STOCKTON UNIFIED SCHOOL DISTRICT

Expanded Learning Opportunities Program (ELOP) - Relocatable Classroom Buildings

The following additions, deletions and revisions to the plans, specifications and Addenda shall become a part of the plans and specifications. It is the responsibility of the General Contractor to submit the information contained in this addendum to all subcontractors and suppliers. The Bidder shall acknowledge receipt of the Addendum in the Bid Proposal. (Addendum number of pages: **32** pages + **77** attachments = **109** total pages).

JOB NUMBER:
23-12909
 DWG. DATE:
02/20/25
 AD1-RIO-
 A801

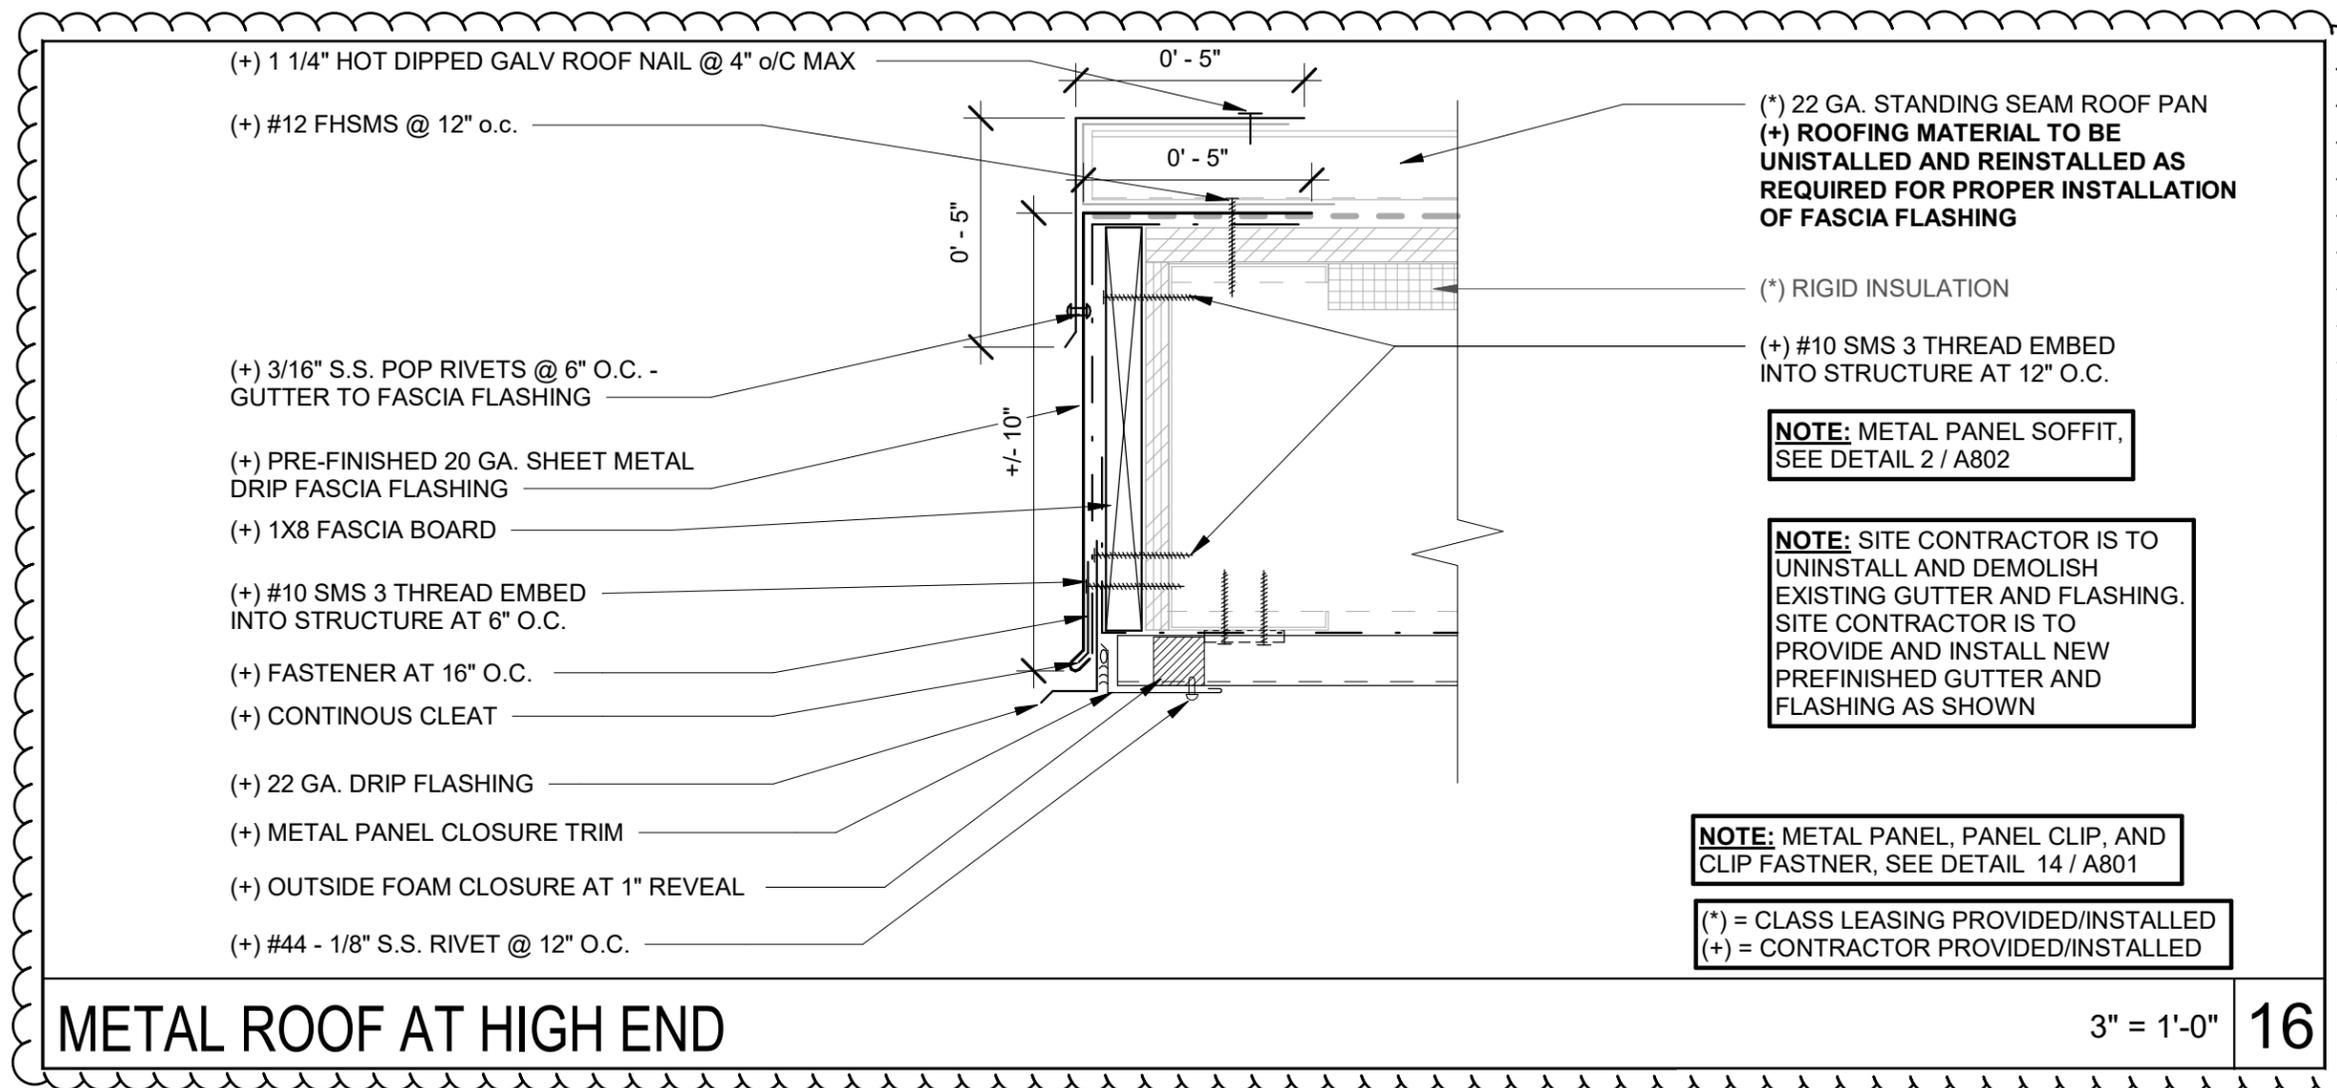
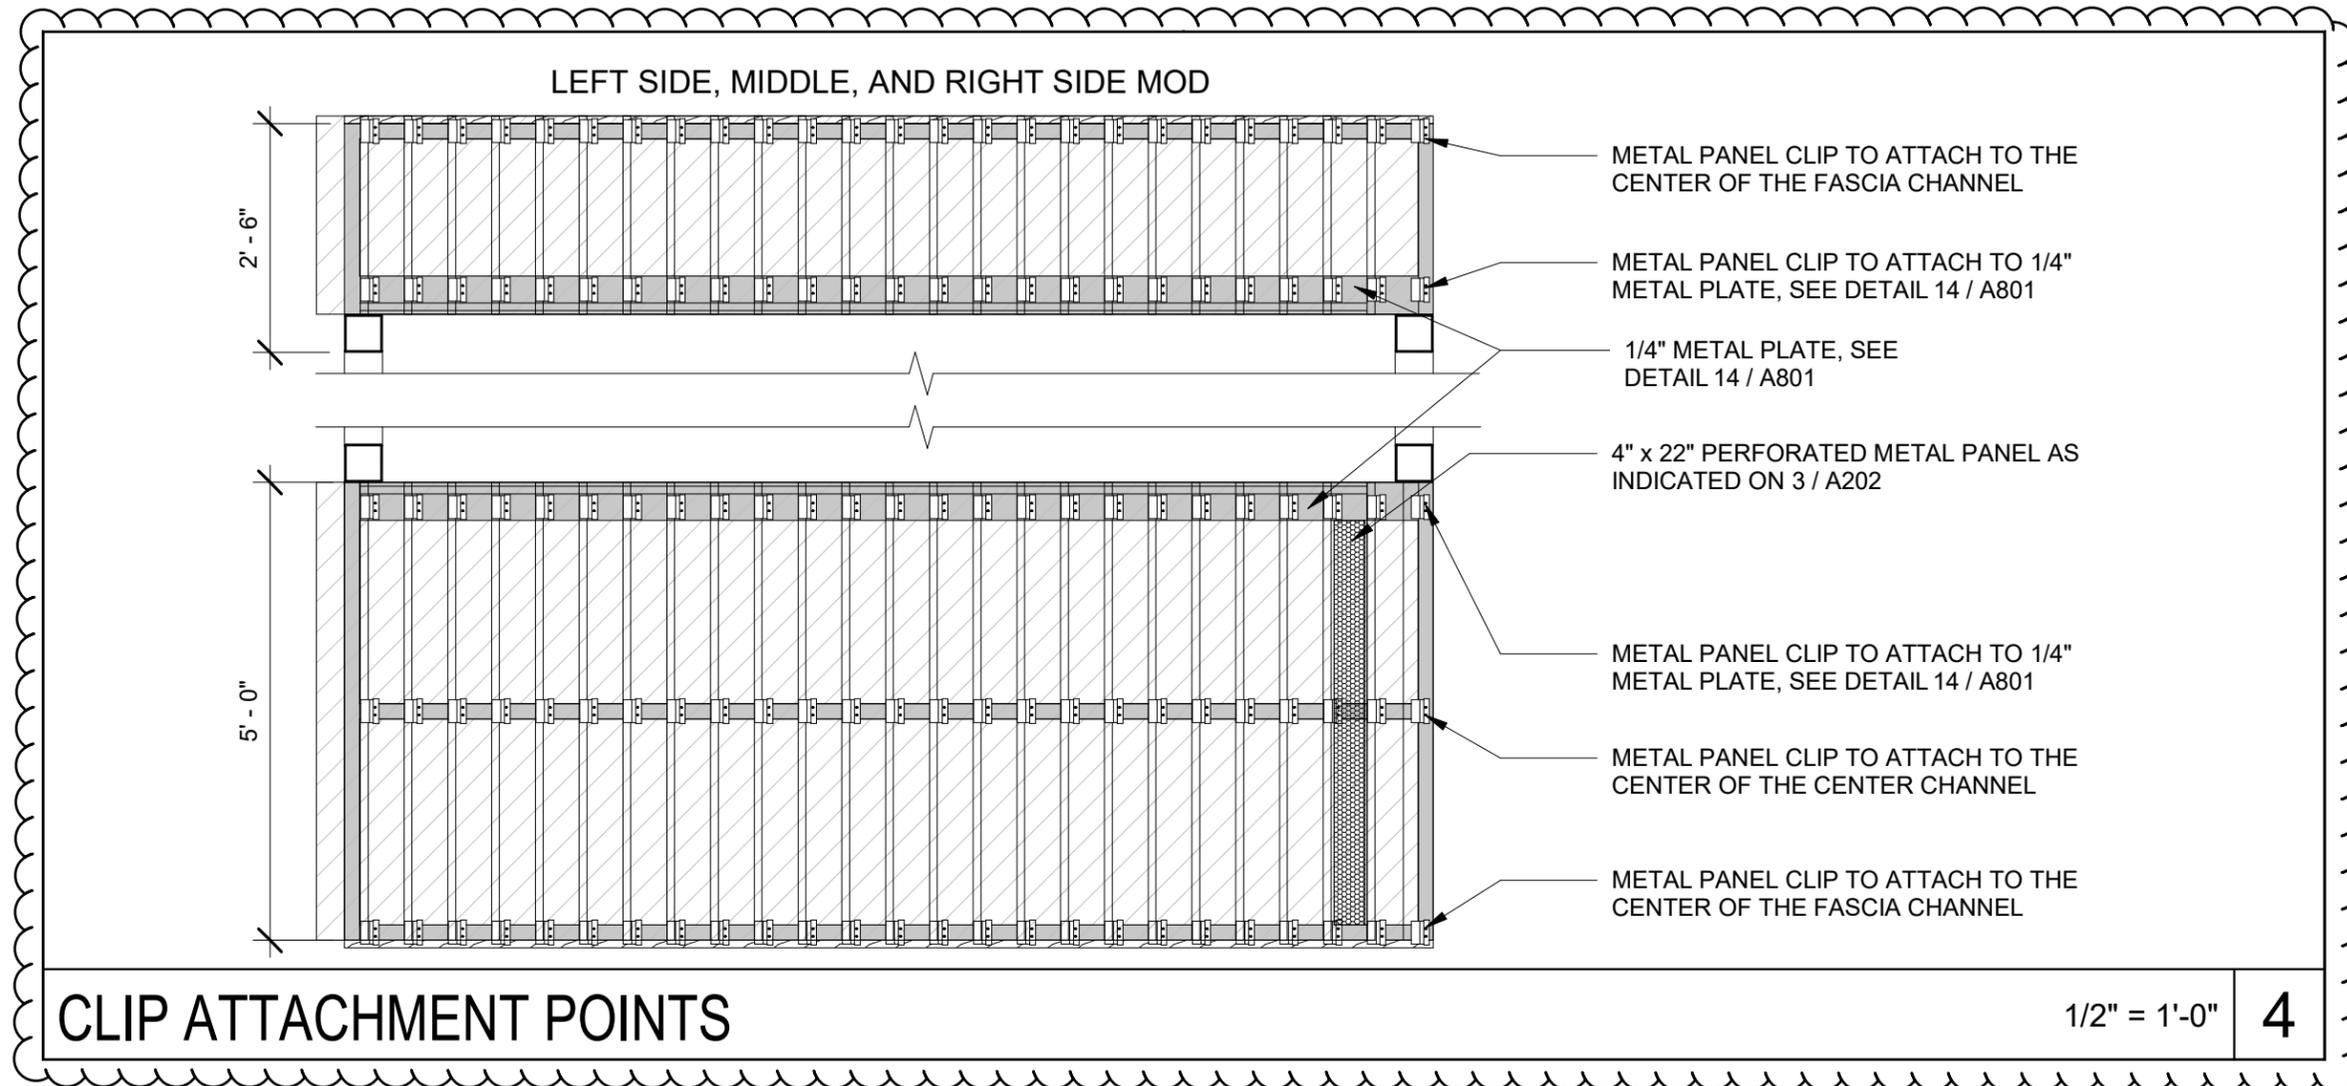
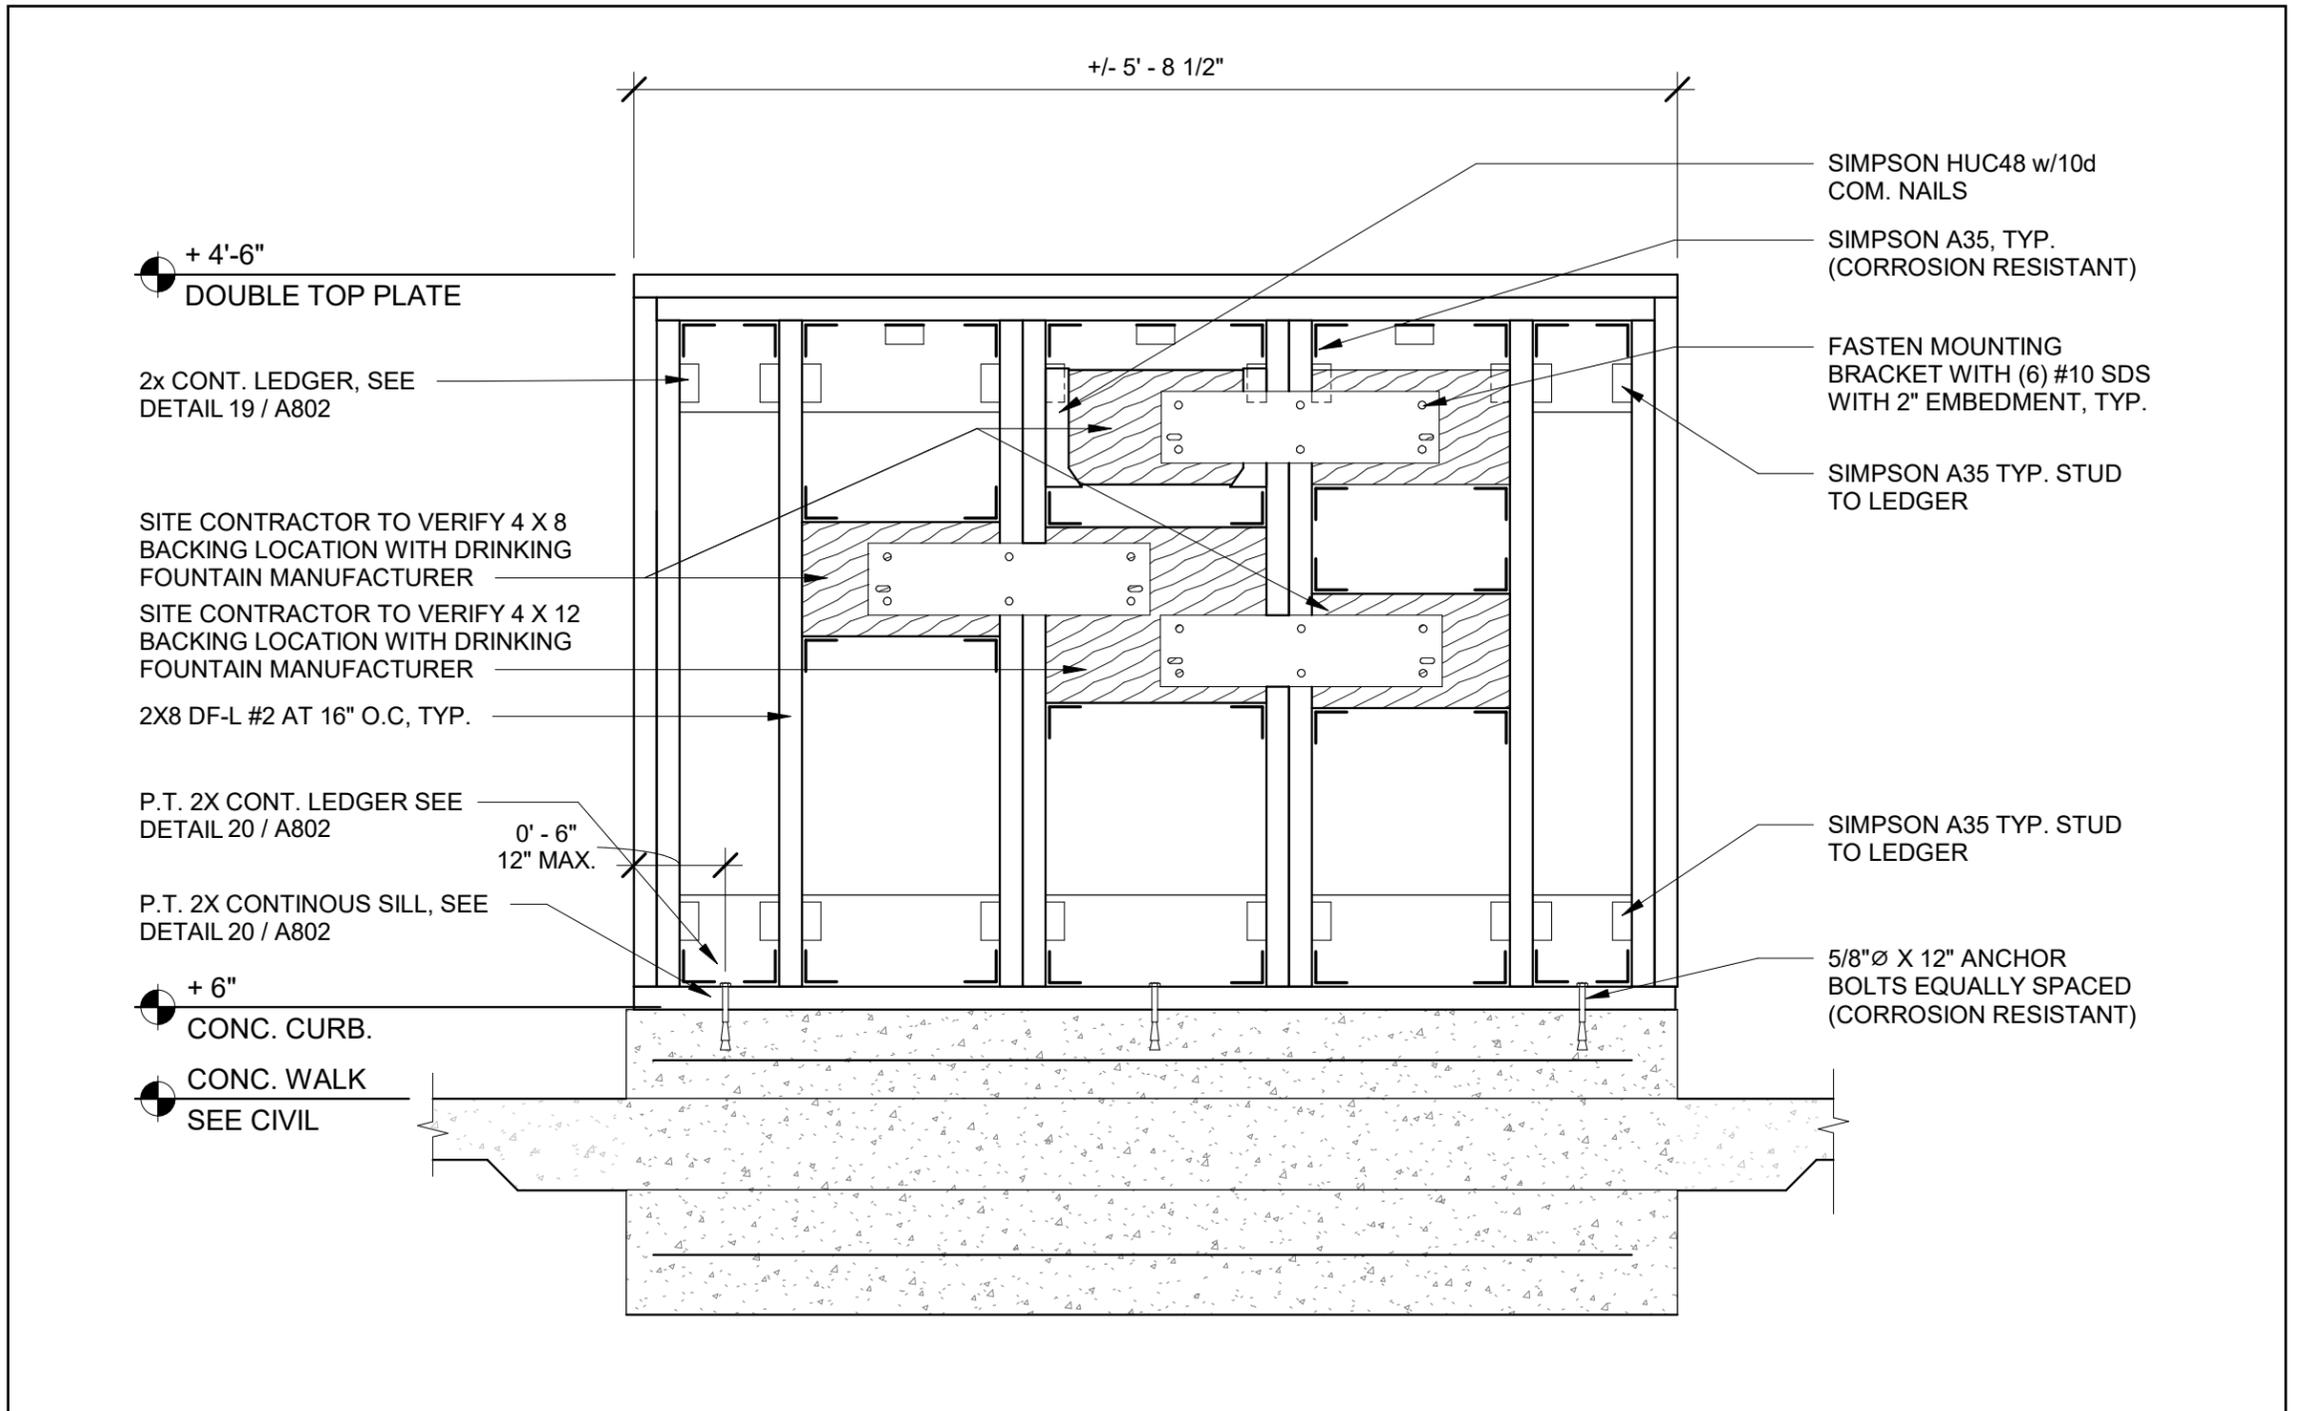
1 - 084: DRAWINGS, SHEET A801 - “EXTERIOR DETAILS”, revise as follows:

A. Detail 14 – Clip fastener note revise to “(2) #12 SMS w/3 THRED INTO STRUCTURE PER CLIP”

B. Per attached drawing **AD1-RIO-A801**

1. Detail 15 and 16 - Additional fastener information has been provided.

AD1-HAM-A100

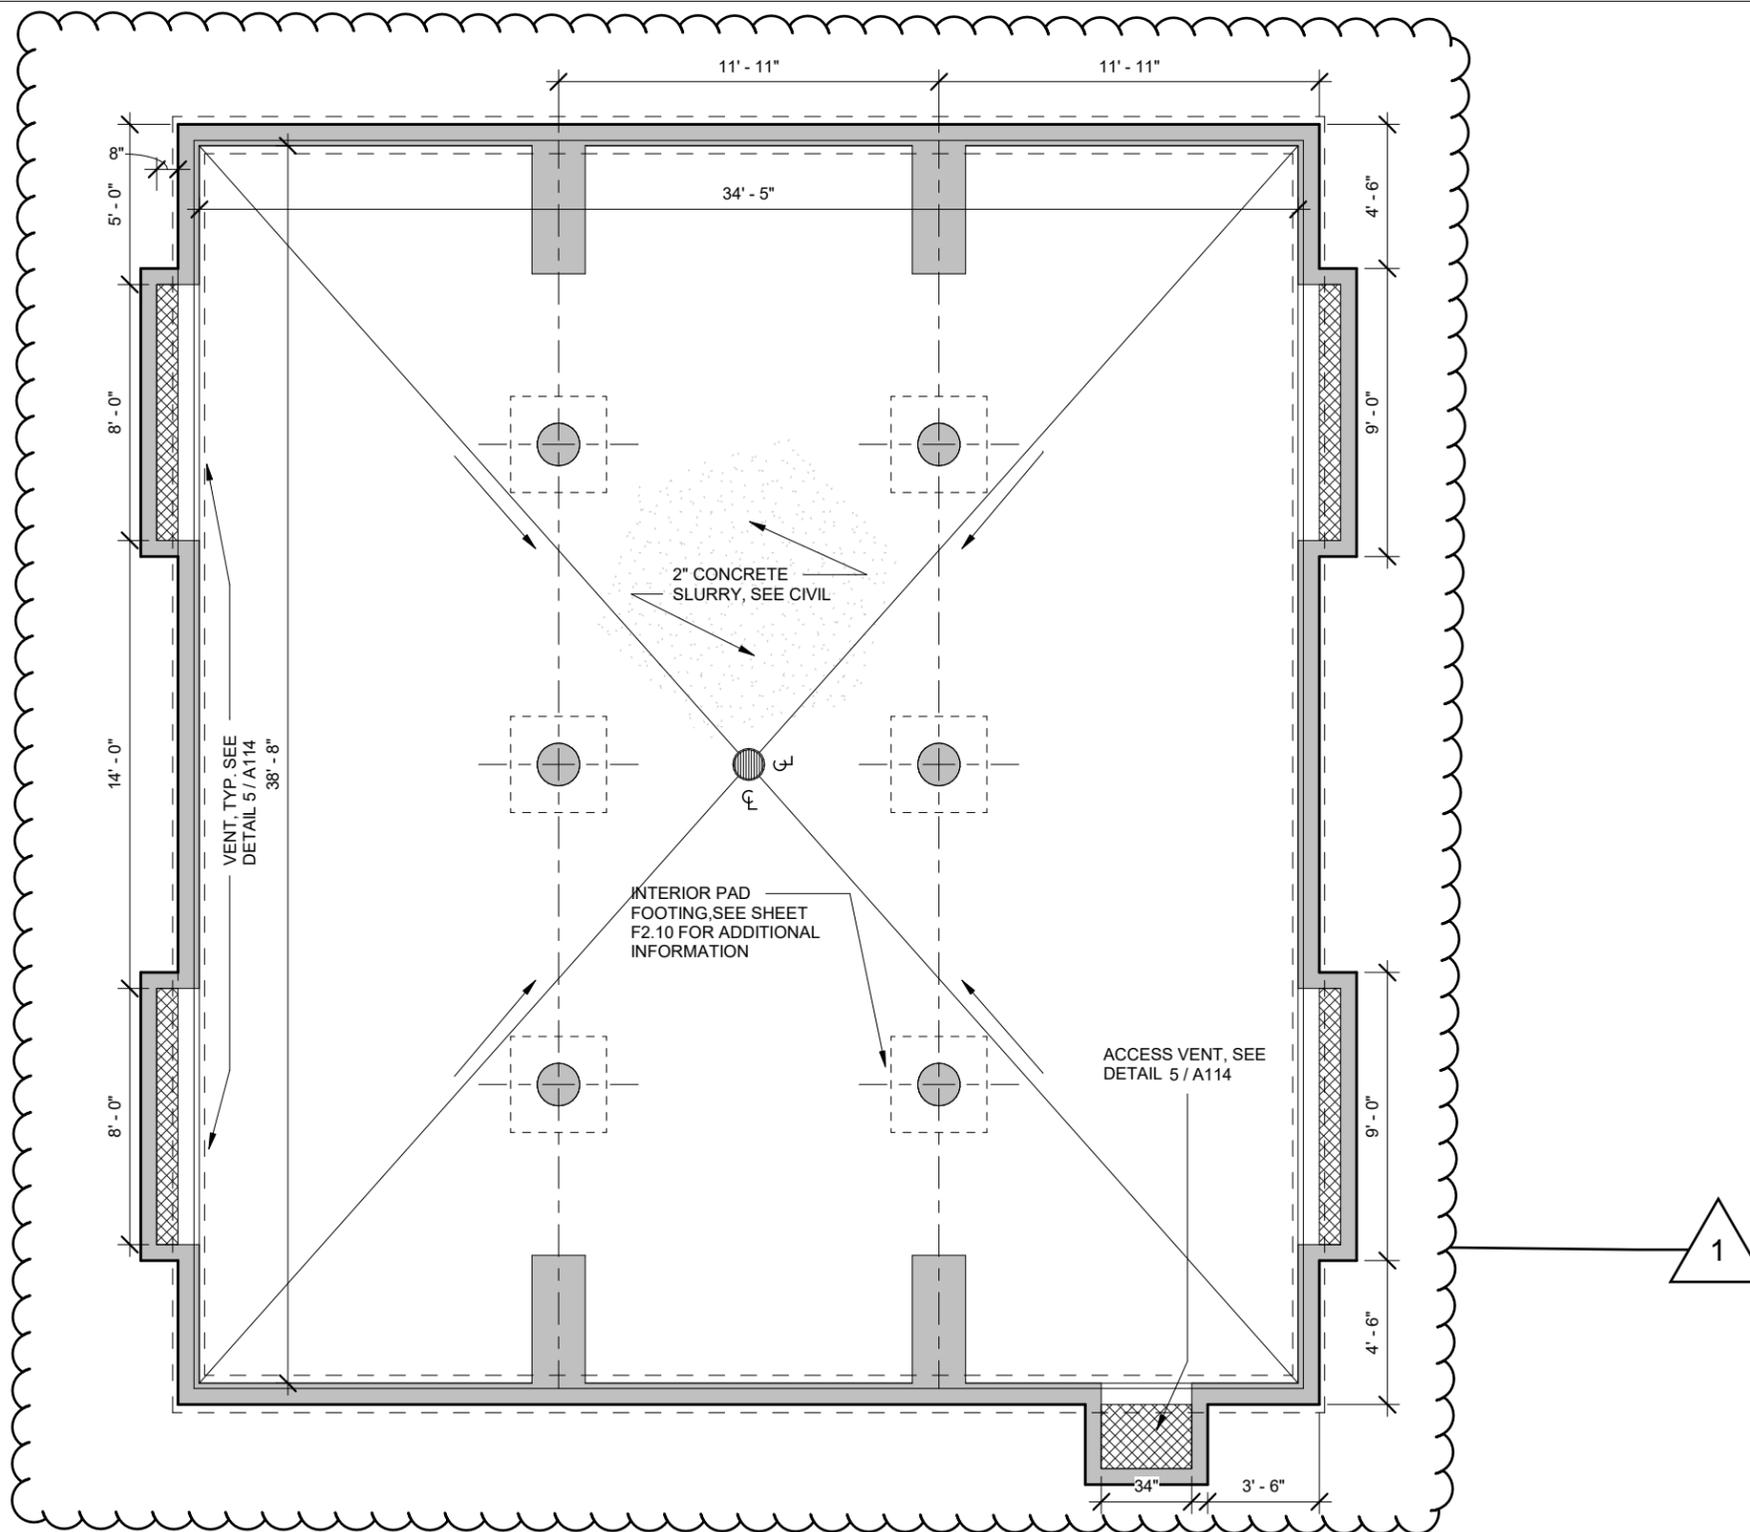
1 - 093: DRAWINGS, SHEET A100 – “OVERALL SITE PLAN”, revise as follows:
